# Access Compliance Report

## Public Rights-of-Way

### (Curb Ramps)

Intersection ID: 48558	Main Street: ARDREY_WOODS_DR	Cross Street: N/A	Location: S
ADA ID: 271A8DE3021C	Ramp Type: PerpDiag	Initial Pass/Fail: Fail	Overall Compliance: No
Codes/Mitigation Info/Possible Solution		Field Measurements/Component Compliance	
Severity Score: 17.5

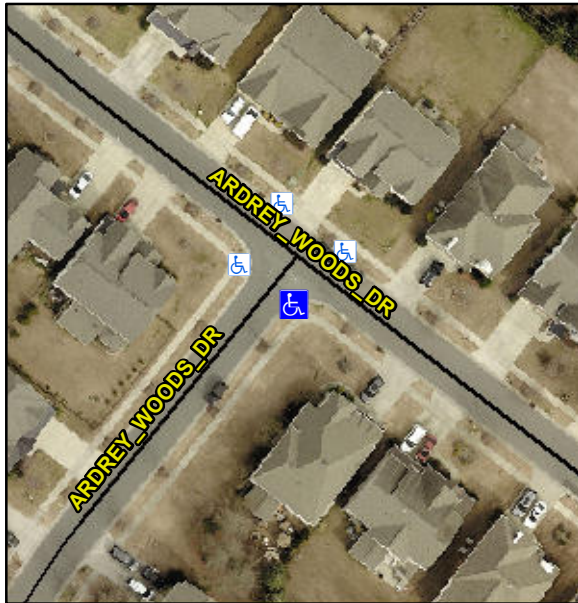
**Not Found, R304.5.1**

Compliance	Description	Data	Compliance	Description	Data
N/A	Ramp Length (in)	71.0	Yes	Ramp Slope (%)	5.1
No	Ramp Width (in)	33.0	Yes	Ramp XSlope (%)	1.2
N/A	Flare Type LT	N/A	N/A	Flare Type RT	N/A
N/A	Flare Slope LT (%)	N/A	N/A	Flare Slope RT (%)	N/A
N/A	Flare Traversable LT?	N/A	N/A	Flare Traversable RT?	N/A
N/A	Landing Length (in)	N/A	N/A	DWS Provided?	N/A
N/A	Landing Width (in)	N/A	N/A	DWS Contrast?	N/A
N/A	Landing Slope (%)	N/A	N/A	DWS Length (in)	N/A
N/A	Landing X Slope (%)	N/A	N/A	DWS Full Width?	N/A
N/A	Landing Curb? (Y/N)	N/A	N/A	DWS Offset (in)	N/A
N/A	Shared Landing?	N/A			
N/A	Gutter Ponding?	N/A	N/A	Gutter Slope (%)	N/A
N/A	Gutter Lip Ht (in)	N/A	N/A	Gutter X Slope (%)	N/A
N/A	Painted X Walk1?	No	N/A	Painted X Walk2?	No
	X Walk 1 Direction	To NE		X Walk 2 Direction	To NW
N/A	X Walk 1 Width (in)	N/A	N/A	X Walk 2 Width (in)	N/A
	X Walk 1 Slope (%)	2.2		X Walk 2 Slope (%)	2.5
	X Walk 1 X Slope (%)	2.3		X Walk 2 X Slope (%)	2.5

**Remove & Replace Curb Ramp With Two New Directional Ramps or Equivalent.**
